Application No. 10/568,784
Amendment dated June 5, 2007
Reply to Office Action of January 5, 2007

Amendments to the Drawings

REMARKS/ARGUMENTS

FIG. 2.

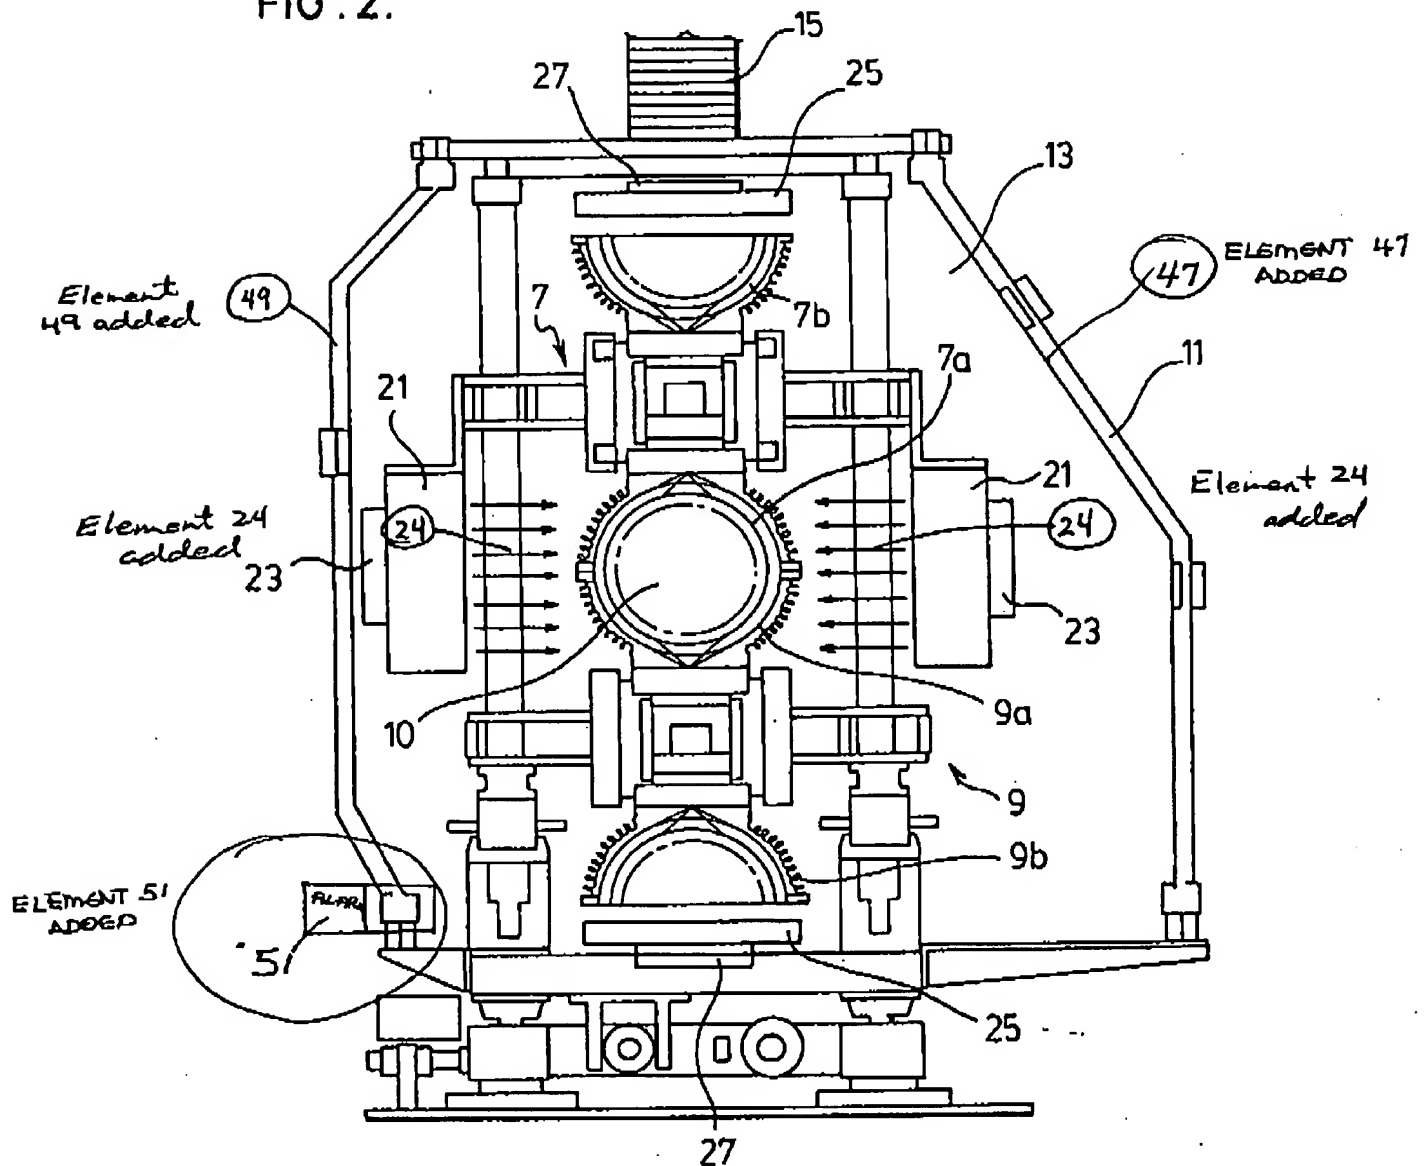
The attached sheets of drawings include changes to Figures 1, 2 and 3. These sheets of drawings replace the previously submitted sheets containing each of these Figures. Element 12 in Figure 1 has been replaced with element 21. Elements 24, 47, 49 and 51 have been added in Figure 2. Element 3 in Figure 3 has been replaced with element 31.
